6. Landscape Updates

7. General Updates

8. Conclusion

General Arrangement C3 Level 8 Roof Plan

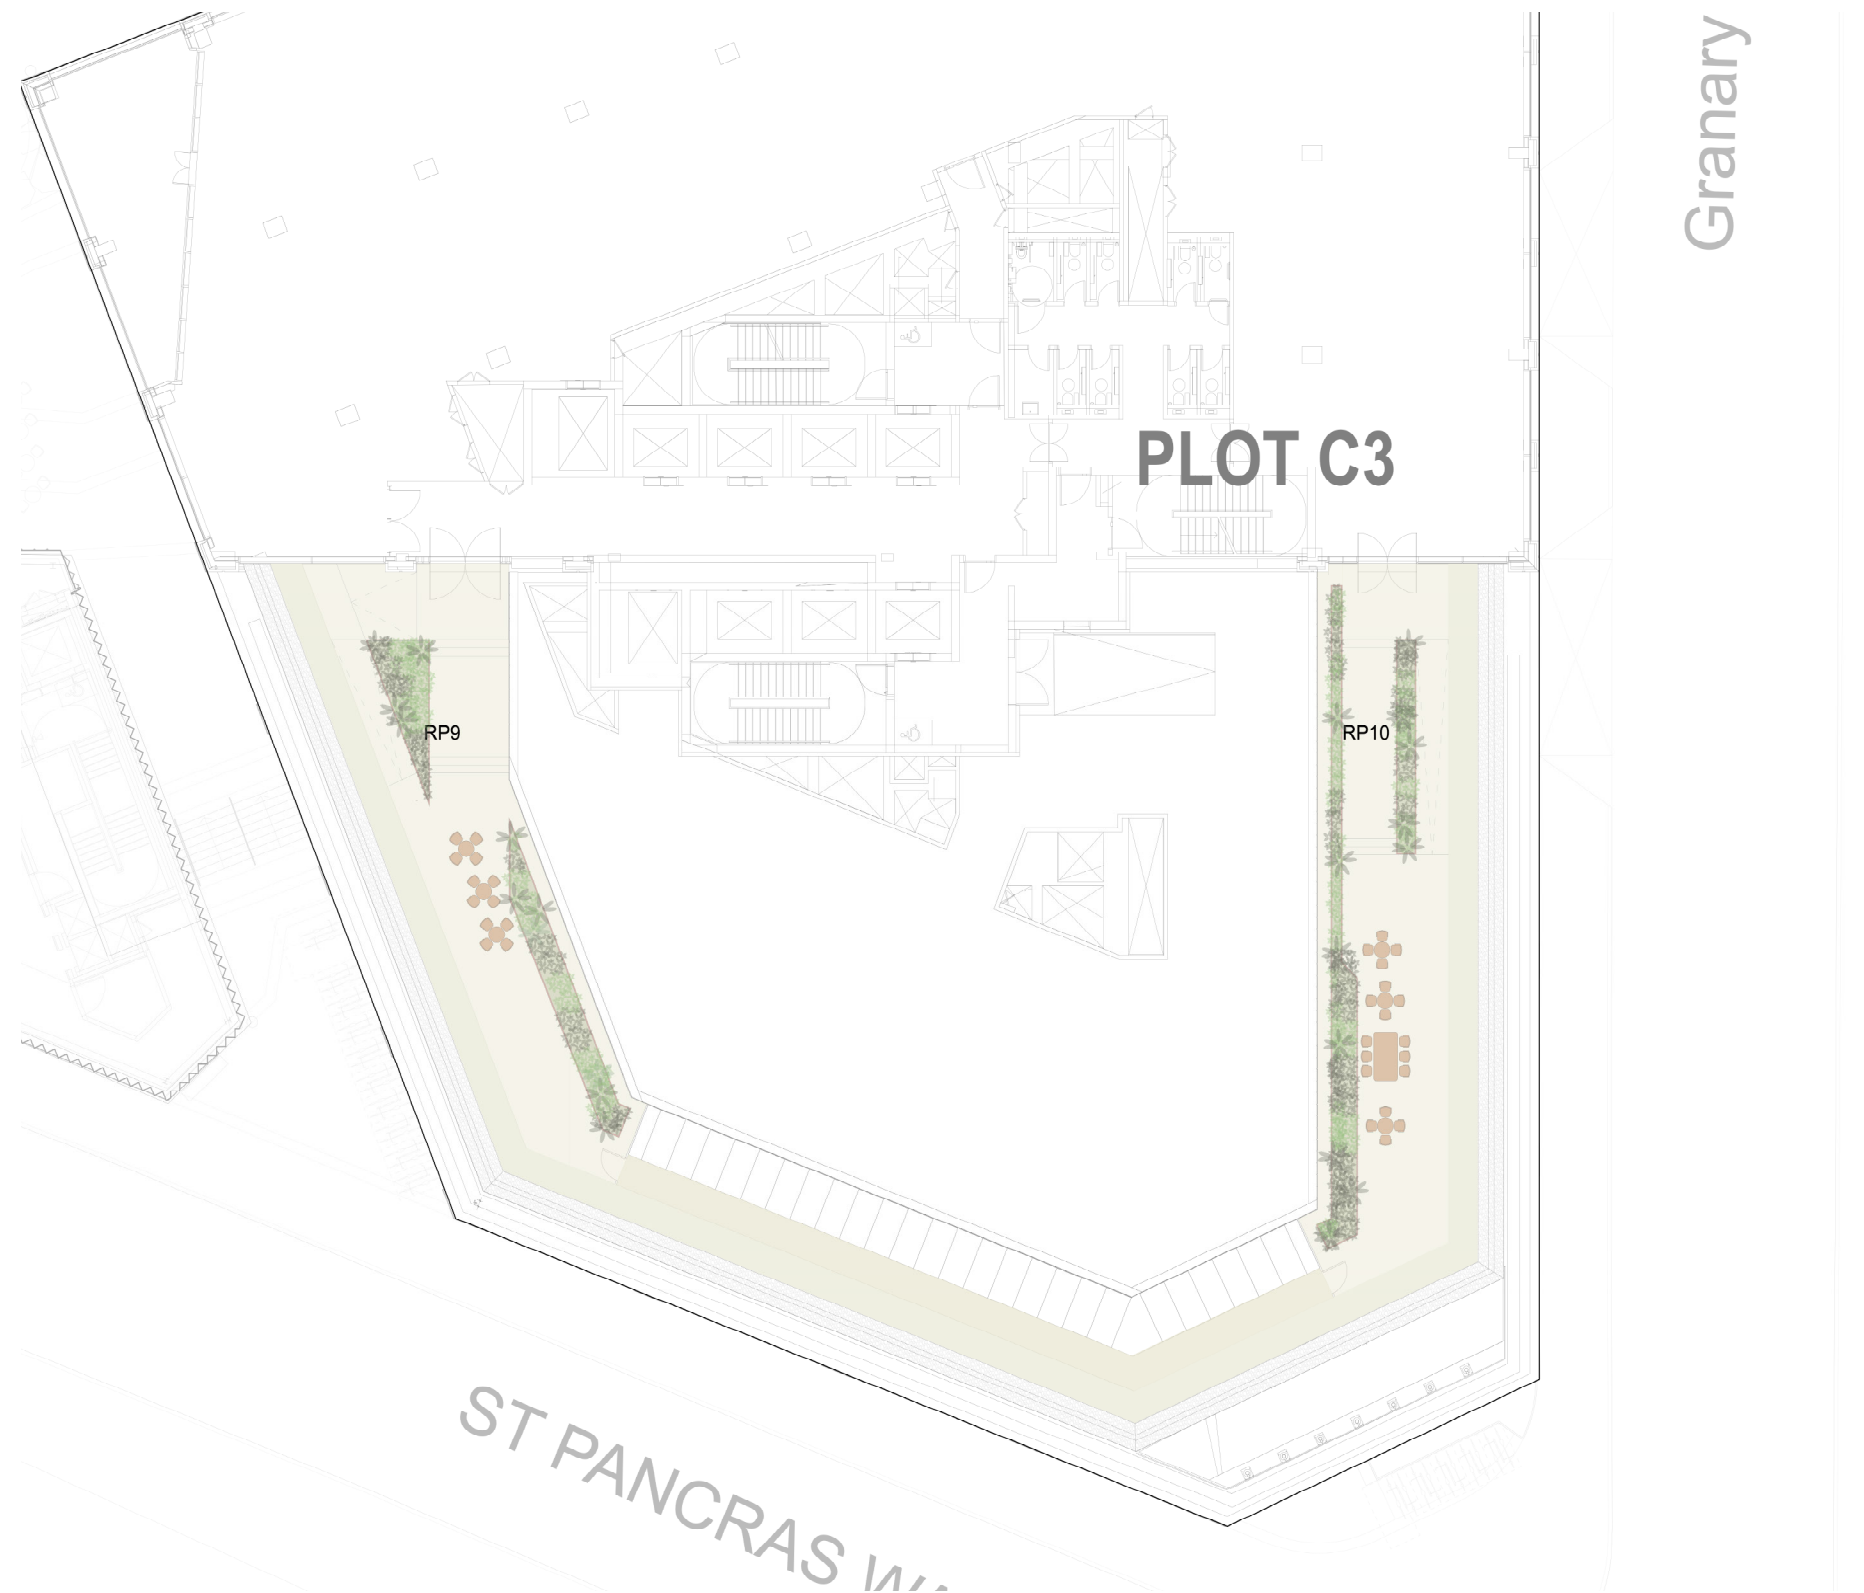
Plot C3 level 8 has two amenity terraces on either side of the roof with a biosolar roof separating the two to the south.

The amenity spaces contain raised planters and informal seating set facing outwards getting views across Camden.

The raised planters contain biodiverse planting and are offset from the building to align with fire regulations.

General Arrangement C4 Level 2 Roof Plan

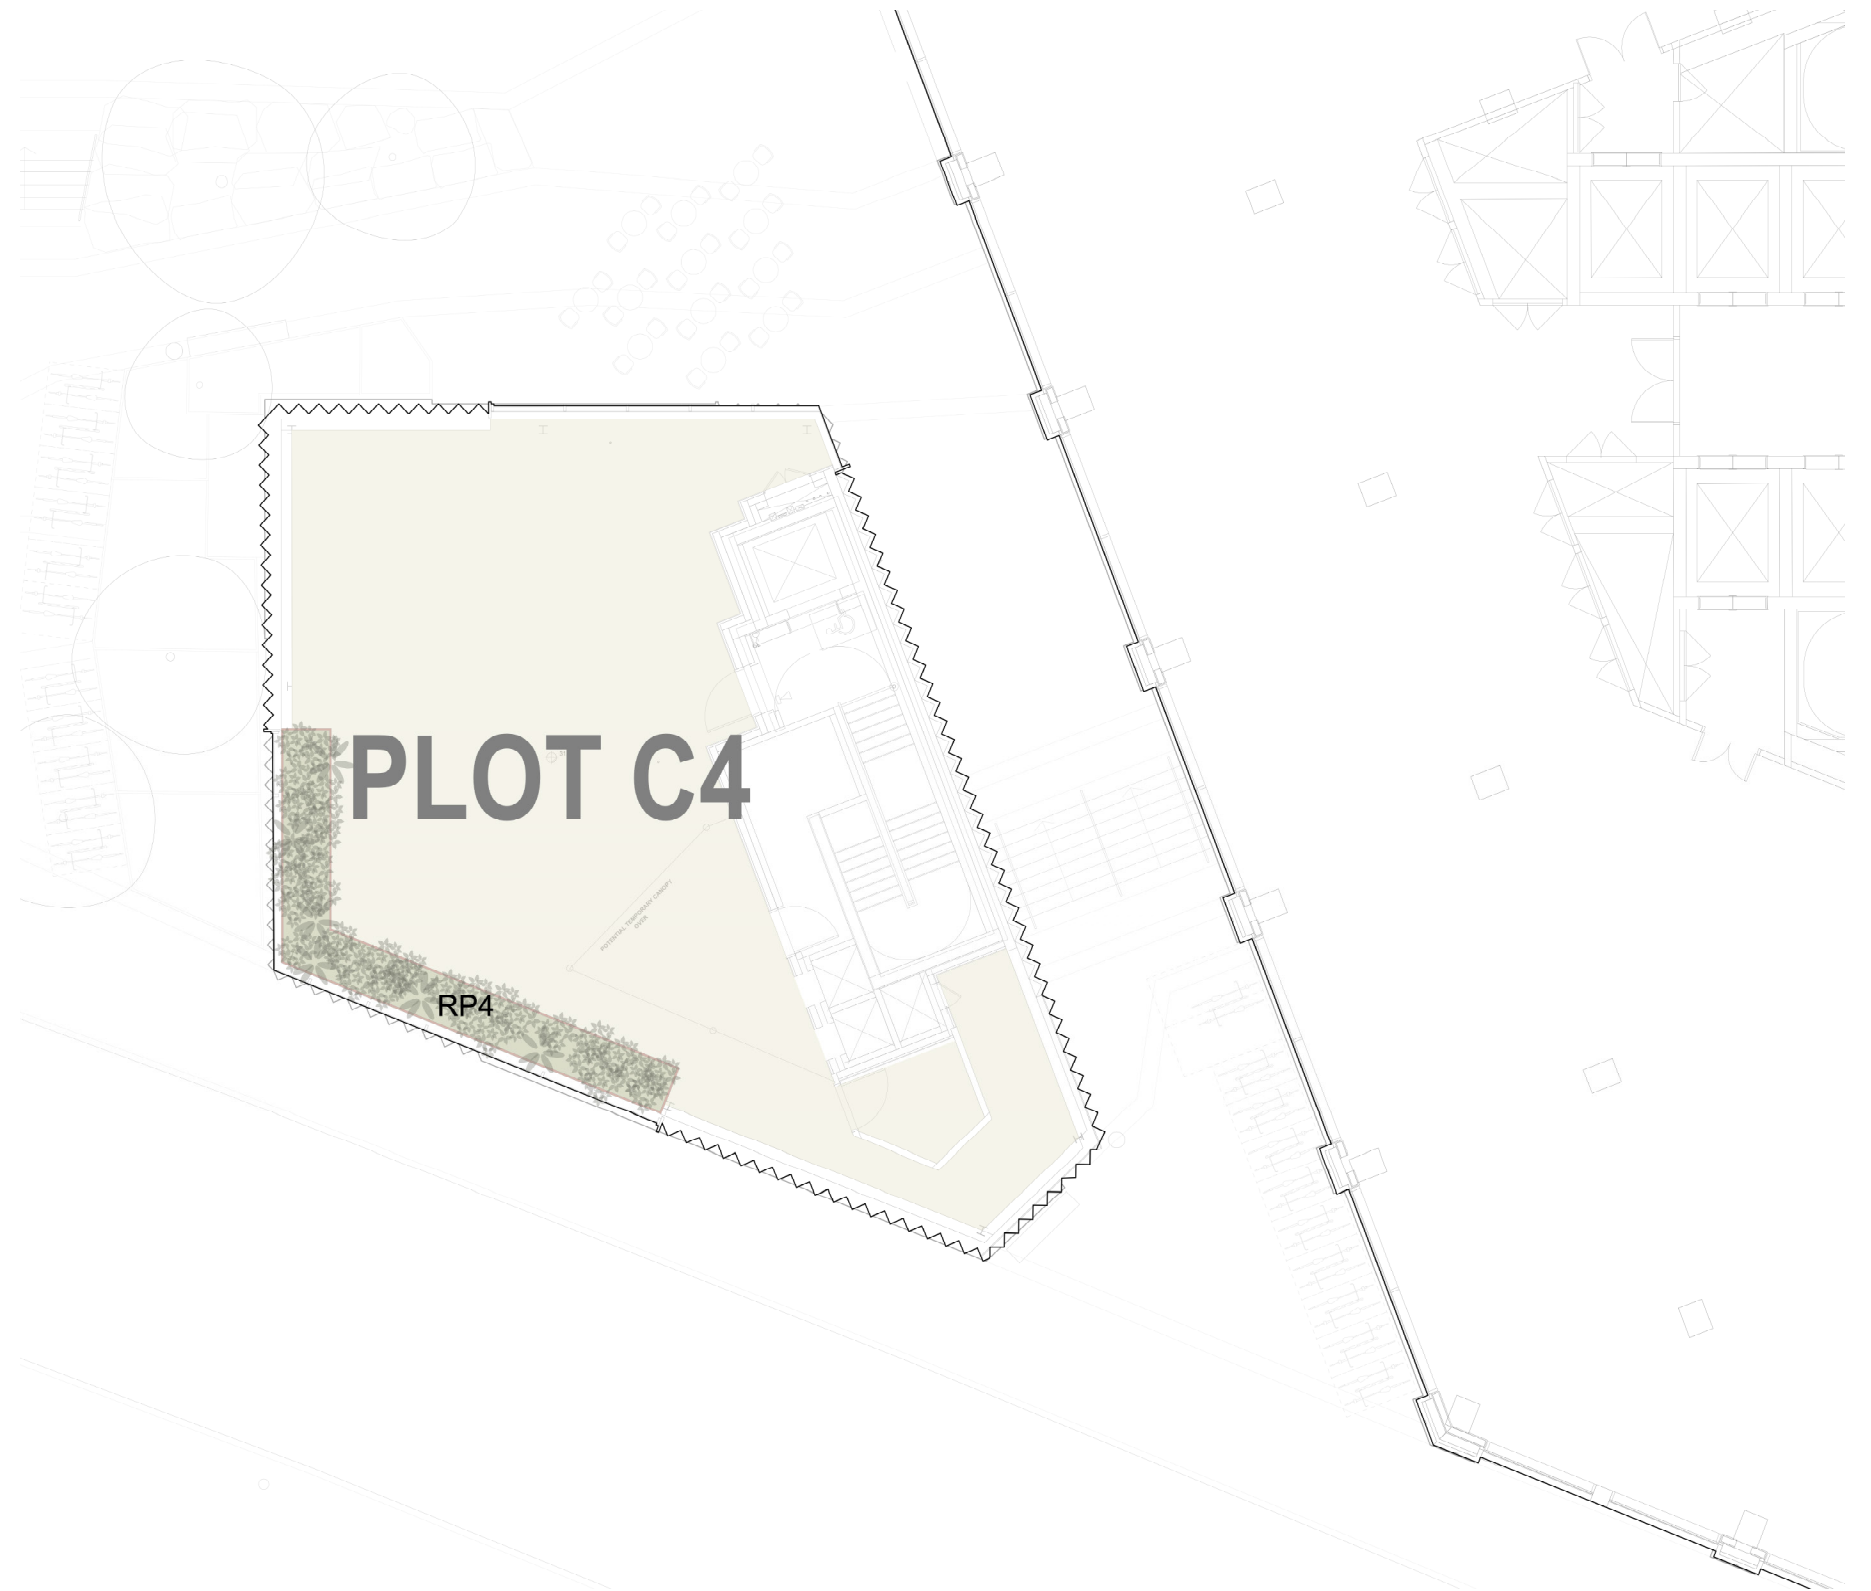
Plot C4 level 2 is flexible space designed to coordinate with the fit out of the building.

There is a raised planter along the south-west edge of the roof space to frame the space and provide a consistent area of soft landscape.

The rest of the area will be left open for future flexibility.
